Corrections of the PALSAR-2 standard products of Spotlight mode and ScanSAR mode
(burst processing) for Interferometric SAR anomalies

Jan 25, 2021

Japan Aerospace Exploration Agency
ALOS-2 Project Team / Earth Observation Research Center

Azimuth frequency before

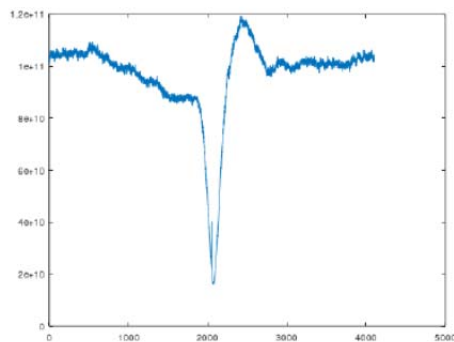
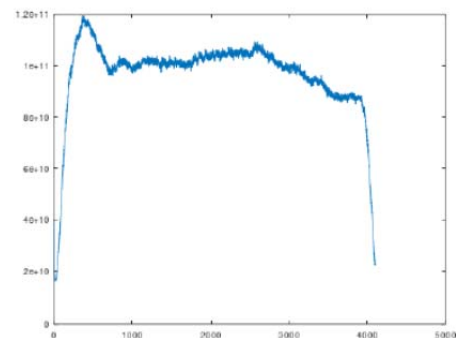
- It was found that Interferometric SAR analysis (InSAR) using the standard product L1.1 of PALSAR-2 Spotlight mode and ScanSAR mode (burst processing) may cause unexplained fringes in the azimuth direction.
- As a result of checking the product processing software, there is an error that the frequency band in azimuth direction is shifted by half of the bandwidth in these modes, and it causes the above-mentioned InSAR error.

- The error in the standard product processing is planned to be fixed in February, 2021. Only the L1.1 product for Spotlight and ScanSAR modes (burst processing) is changed. Stripmap and ScanSAR (full aperture processing) modes and the product levels other than L1.1 are not changed.
- Please note that InSAR processing between products that have been processed before and after the correction will not give the correct results. For products that have been processed before correction, it is possible to convert them to the same

Alternately multiply 1, -1, 1, -1, ... for each azimuth line.

(Equivalent to a $1/2$ shift in bandwidth)
